RE: RESPONSE TO COMMENT – BASIC ASSESSMENT PROCESS: PROPOSED PRIMARY DWELLING ON PORTION 79 OF FARM 205, RUYGTE VALLEY: SUBMISSION OF FINAL BASIC ASSESSMENT REPORT TO THE DFFE

Reference: 4/10/2/K40D/RUYGTE VALLEY 205/79, SEDGEFIELD

RE: AMENDED DRAFT BASIC ASSESSMENT REPORT FOR THE PROPOSED DEVELOPMENT OF A PRIMARY DWELLING AND ACCESS ROAD ON PORTION 79 OF FARM 205, RUYGTE VALLEY, SEDGEFIELD, WESTERN CAPE

Fig. 1. Preferred Alternative SDP, as extracted from pg. 22 & 60 of the DBAR, Eco Route, November 2025.

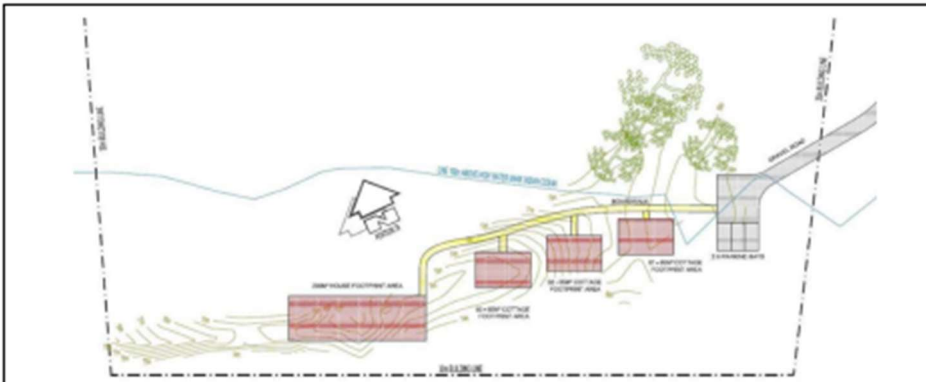
No revised Preferred Alternative SDP could be found in the amended DBAR of January 2026, nor its appendices.

An updated Constraints Map (Appendix B1) (**Fig. 3**), however shows a slight change to the SDP contained in the DBAR of November 2025 (**Fig. 1**). The three cottages appear to have been shifted slightly eastwards, however not northwards.

Fig. 3. Site Constraints Map, showing SDP, Planning Space, 31 January 2026, amended DBAR

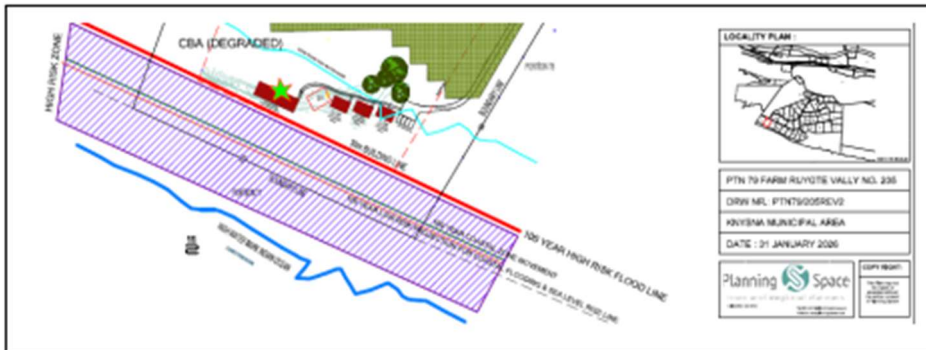
The total development footprint area of the preferred alternative has increased from that stated in the DBAR of November 2025 of approx. 1175m², to approx. 1375m² in the amended DBAR of January 2026.
